ADDENDUM 001

This Addendum is hereby made a part of the Contract Documents dated August 7, 2023.

Specialty Surgical Hospital – Aesthetic Breast Reconstructive Center
6330 Mourning Dove Drive
Baton Rouge, Louisiana 70817
GHC Project No. 6022158

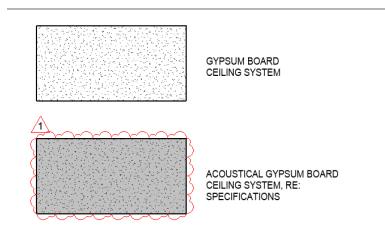
- b. **Doctor’s Covered Parking Canopy – 6/AS103:** Refer to Sections 1/A301 (which directs you to 5/A403 then 3/A453), 3/A303 and 4/A303 (both directing you to 3/A403 then 4/A453) and 4/A303, all of which **do not** show any metal soffit panels; however, if the soffit panels are required at the Staff Parking (refer to Item No. 2), why would they not be

required at the Doctor Parking? Please confirm if the Doctor Covered Parking is to receive the wood grain soffit panels?

Response: Doctor's covered parking canopy will not receive wood grain soffit panels
